**SAYA, SE-CH2H CHAFF CUTTER  
(Electric Motor Operated)**

Report No.: Machine-660/1724

Type of test : COMMERCIAL(ICT)  
Name of Machine : Chaff Cutter (Electric Motor Operated)  
Period of test : July, 2024 to August, 2024  
Test Report No. : **Machine-660/1724**  
Month / Year : September, 2024

## 12. SUMMARY OF OBSERVATION, COMMENTS & RECOMMENDATIONS

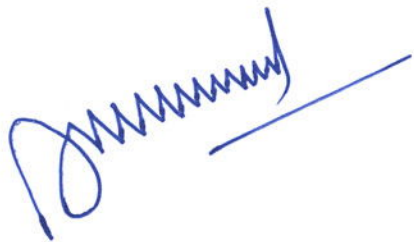
- 12.1** Following modifications/improvements, being safety requirement, are required to be made to develop the chaff cutter as conforming to IS 15542:2005.
- 12.1.1 A minimum cautionary notice as per IS 15542:2005 shall be written in vernacular language on a labeling plate.
- 12.2** Blade should be marked with size code, Batch code and thickness as per IS 1511:1979 (Reaffirmed 2012).
- 12.3** The chemical composition of blade does not conform the IS 1511:1979 (Reaffirmed 2012). This should be looked into for corrective action.
- 12.4** **The following dimensions of chute for electric motor operated chaff cutter are not conforming to the recommendations of Dangerous Machine (Regulation) Rules, 2007 and needs to be looked into.**

S. No.	Description	Observation	Remarks
i)	Provision for changing the angle of placement of trough shall be made.	Not provided	<b>Does not conform</b>
ii)	At the rear side of the trough a support shall be made.	Not provided	<b>Does not conform</b>

- 12.5** **Marking/labeling:**  
The labeling plate does not reveal all the required information. It is therefore recommended that a suitable labeling plate covering all essential components, inter alia, the following must be provided:
- i) Country of origin
  - ii) Power rating (kW)
  - iii) Rated input capacity
  - iv) Recommended rpm of flywheel or cylinder
- 12.6** **Adequacy of literature supplied with the machine:**  
Operation, Service, Maintenance manual cum part catalogue of chaff cutter in English were not provided for reference during the test. It is however, recommended that same may be revised and brought out in Hindi & other regional languages as per IS 8132:1999 (Reaffirmed 2004) for the sake of user & technical personnel.

Our reference	Applicant Comments
12.1.1	We Will Improve in mass production.
12.2	We Will Improve in mass production.
12.3	We Will Improve in mass production.
12.5	Adequate information can be provided.
12.6	Adequate literature can be provided.
